Application No.	Applicant(s)
	10/506,959	ANDERSON ET AL.
Office Action Summary	Examiner	Art Unit
	GERALD LANDRY II	3763
The MAILING DATE of this communication appears on the cover sheet with the correspondence address Period for Reply		
 A SHORTENED STATUTORY PERIOD FOR REPLY IS SET TO EXPIRE <u>3</u> MONTH(S) OR THIRTY (30) DAYS, WHICHEVER IS LONGER, FROM THE MAILING DATE OF THIS COMMUNICATION. Extensions of time may be available under the provisions of 37 CFR 1.136(a). In no event, however, may a reply be timely filed after SIX (6) MONTHS from the mailing date of this communication. If NO period for reply is specified above, the maximum statutory period will apply and will expire SIX (6) MONTHS from the mailing date of this communication. Failure to reply within the set or extended period for reply will, by statute, cause the application to become ABANDONED (35 U.S.C. § 133). Any reply received by the Office later than three months after the mailing date of this communication, even if timely filed, may reduce any earned patent term adjustment. See 37 CFR 1.704(b).

DETAILED ACTION

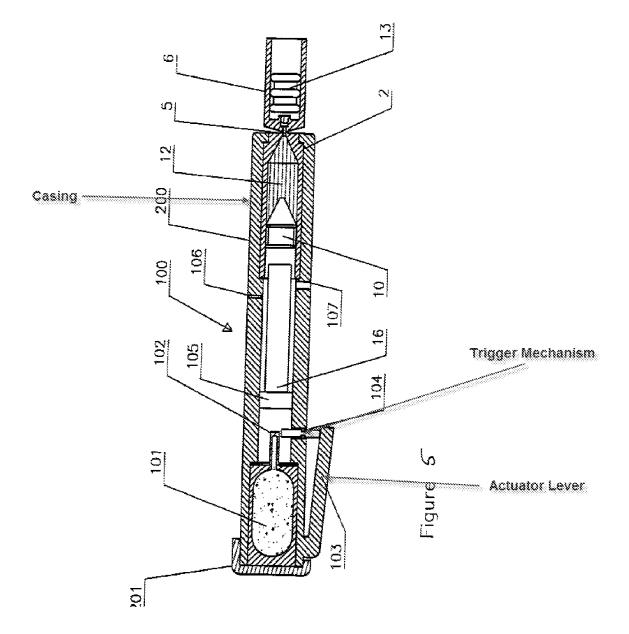
2. Claims 31, 33, and 37 are rejected under 35 U.S.C. 102(b) as being anticipated by U.S.

Regarding claims 31, 33, and 37, Weston teaches a needleless injection device (100),

comprising a casing; a cartridge (1) containing a medicament for injection and an orifice (5) at one end thereof through which the medicament is driven for injection through a patient's skin; a drive mechanism (101) which upon actuation applies force to the medicament, forcing the medicament out of the orifice and through the patient's skin; a trigger mechanism (refer to marked-up figure below) which actuates the drive mechanism; a safety mechanism (102) which, in a first configuration (intact), prevents the trigger mechanism from actuating the drive

mechanism and in a second configuration (detached) allows trigger mechanism to actuate the drive mechanism; and an actuator lever (refer to marked-up figure below) which moves the safety mechanism from its first configuration into its second configuration; wherein the actuator mechanism comprises a portion extending outside of the casing which portion is accessible to a user and which when the portion is moved by the user the movement brings the safety mechanism into its second configuration (refer to marked-up figure below); wherein the safety mechanism in its first configuration prevents the trigger mechanism from moving (refer to marked-up figure below); the trigger mechanism may rest on the safety mechanism, and until the safety mechanism is forced into the safety mechanism comprises an obstructer portion which in the first configuration obstructs, and in the second configuration allows, movement of the trigger mechanism until the safety mechanism in and of itself obstructs the trigger mechanism until the safety mechanism becomes detached).
